**Planning Staff Report to
Greenville Planning Commission
January 14, 2022
for the January 20, 2022 Public Hearing**

Docket Number: SD 21-747

Proposal: Major subdivision for an 18 lot, single-family attached residential development

LEACH STREET COMMONS

PRELIMINARY PLAN

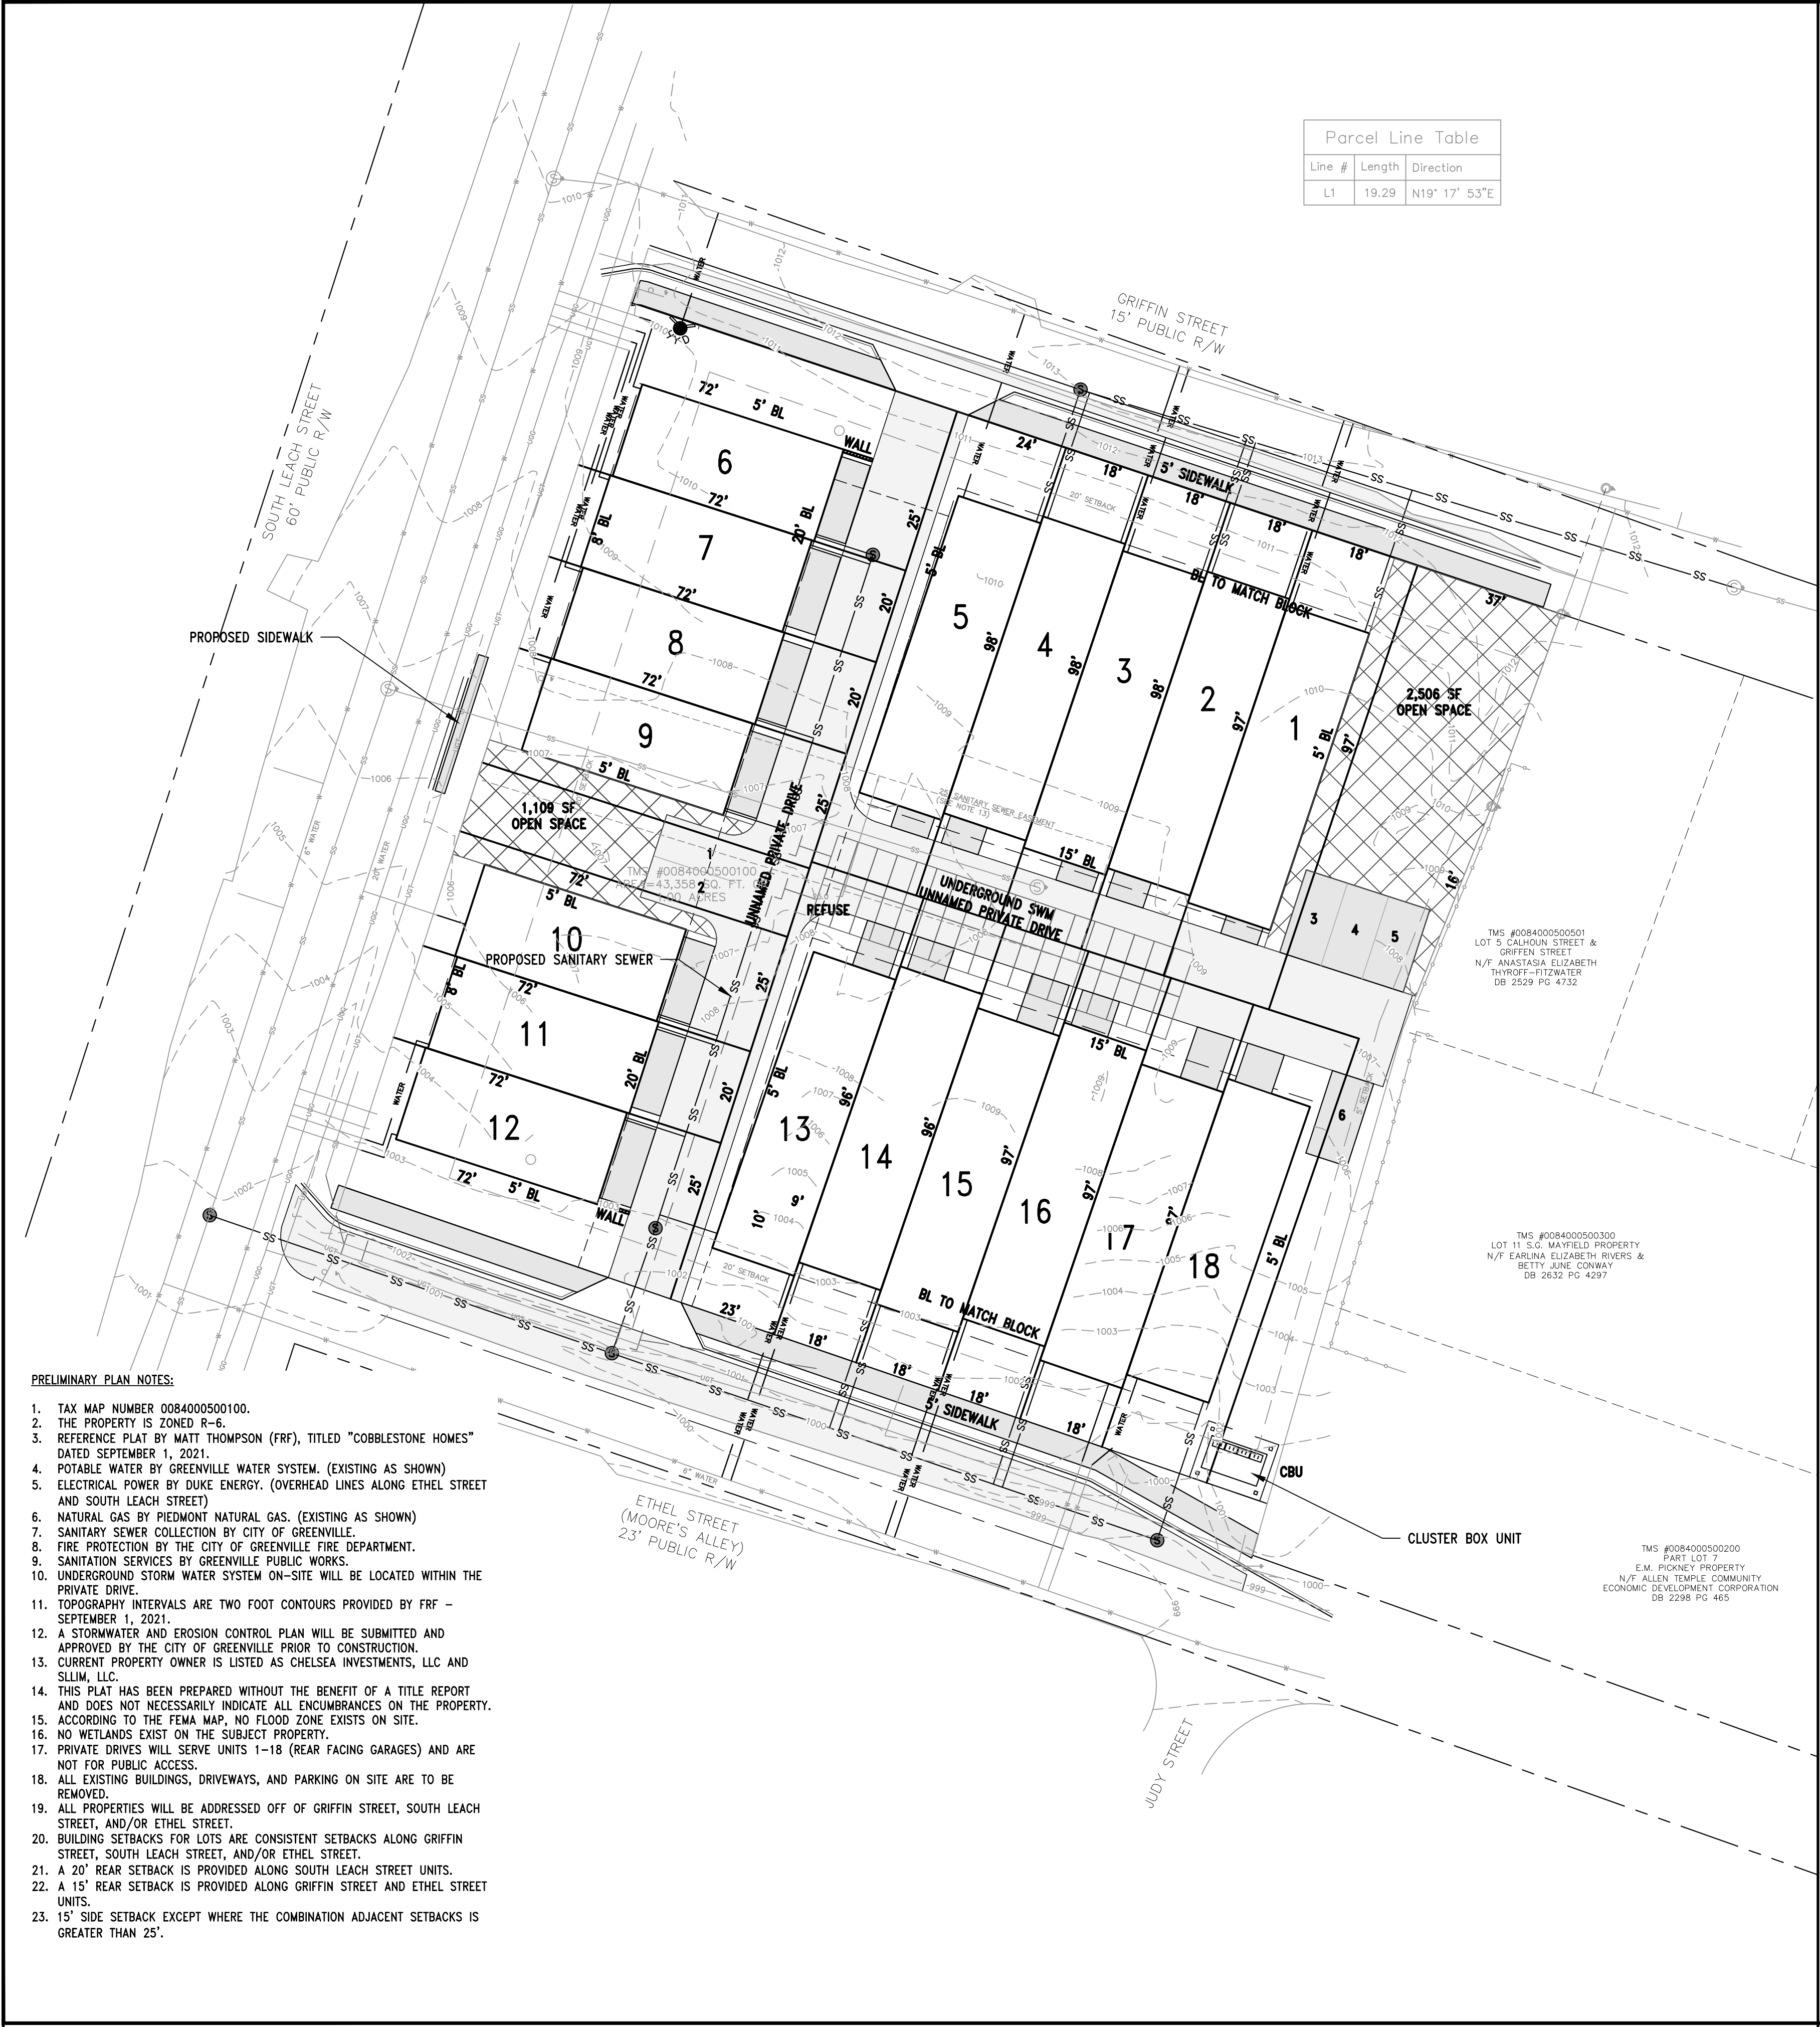
The location of units on the plan reflect compliance with minimum dimensional standards for single-family attached residences. Orientation of the front of the structures towards the existing streets, as proposed, is desirable and consistent with standards for attached residential units. Corner units should incorporate a design that presents similar architectural features on the secondary frontage as is required on the front of the units, specifically relevant to units on Lots 6 and 12.

No new roadways are proposed with this application. Griffin Street will be widened with curbing on the south side of the street to the extent of the project to allow for sufficient width for one-way traffic. The apron at the Griffin Street intersection with S. Leach Street will need to be replaced due to its poor condition. Ethel Street will be widened to allow for sufficient width for two-way traffic and fire aerial access, as necessary. Curbing will be installed along the north side of Ethel Street, with the street width tapering to the existing width of the street as it approaches the eastern extent of the project. Improvements to S. Leach Street include the closure of the existing curb cut to match the existing curbing, curb lawn, and sidewalk.

Existing sidewalks and curb lawn will be maintained along S. Leach Street. New 5-foot-wide sidewalks, with 2-foot curb lawns, are proposed on the development side of both Griffin Street and Ethel Street. The front entrance of each new unit will need to be connected to the existing or new sidewalks proposed along the street. The Cluster Box Unit mail kiosk will need a sidewalk connection to the Ethel Street sidewalk.

- 1) Design of the single-family attached units shall meet standards consistent with the multifamily design standards and will be reviewed for compliance during building permit plan review.
- 2) Corner units shall incorporate a design that presents similar architectural features on the secondary frontage as is required on the front of the units, specifically relevant to units on Lots 6 and 12.
- 3) The front entrance of each new unit shall be connected to the existing or new sidewalks proposed along each street.
- 4) The Cluster Box Unit mail kiosk shall have a sidewalk connection to the Ethel Street sidewalk.

- 6) Sidewalk on Ethel Street and Griffin Street will also need to be five-foot sidewalk and two-foot curb lawn.

- 10) Due to the utility cuts on Ethel Street and Griffin Street, these streets will need to be milled and repaved the entire length of the new development.

- 11) The driveway apron at the intersection of Griffin Street and South Leach Street will need to be removed and replaced. It is already in bad shape, but with all the traffic during construction, it will definitely need to be redone.
